Access Compliance Report

Public Rights-of-Way

Intersection ID: 14069	Main Street: CLARICE_AV	Cross Street: E_8TH_ST	Location:	N
ADA ID: D02BE6EDEC87	Ramp Type: PerpDiag	Initial Pass/Fail: Fail	Overall Compliance: No	Severity Score: 12.5

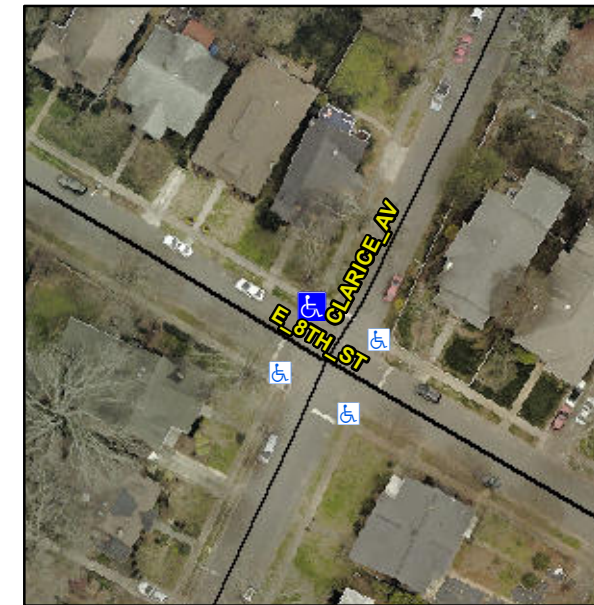
Not Found, R304.2.2

Compliance	Description	Data	Compliance	Description	Data
N/A	Ramp Length (in)	61.0	No	Ramp Slope (%)	11.1
Yes	Ramp Width (in)	48.0	Yes	Ramp XSlope (%)	0.8
N/A	Flare Type LT	N/A	N/A	Flare Type RT	N/A
N/A	Flare Slope LT (%)	N/A	N/A	Flare Slope RT (%)	N/A
N/A	Flare Traversable LT?	N/A	N/A	Flare Traversable RT?	N/A
N/A	Landing Length (in)	N/A	N/A	DWS Provided?	N/A
N/A	Landing Width (in)	N/A	N/A	DWS Contrast?	N/A
N/A	Landing Slope (%)	N/A	N/A	DWS Length (in)	N/A
N/A	Landing X Slope (%)	N/A	N/A	DWS Full Width?	N/A
N/A	Landing Curb? (Y/N)	N/A	N/A	DWS Offset (in)	N/A
N/A	Shared Landing?	N/A			
N/A	Gutter Ponding?	N/A	N/A	Gutter Slope (%)	N/A
N/A	Gutter Lip Ht (in)	N/A	N/A	Gutter X Slope (%)	N/A
N/A	Painted X Walk1?	No	N/A	Painted X Walk2?	No
	X Walk 1 Direction	To SW		X Walk 2 Direction	To SE
N/A	X Walk 1 Width (in)	N/A	N/A	X Walk 2 Width (in)	N/A
	X Walk 1 Slope (%)	1.5		X Walk 2 Slope (%)	1.7
	X Walk 1 X Slope (%)	1.8		X Walk 2 X Slope (%)	1.1

Remove & Replace Curb Ramp With Two New Directional Ramps or Equivalent.
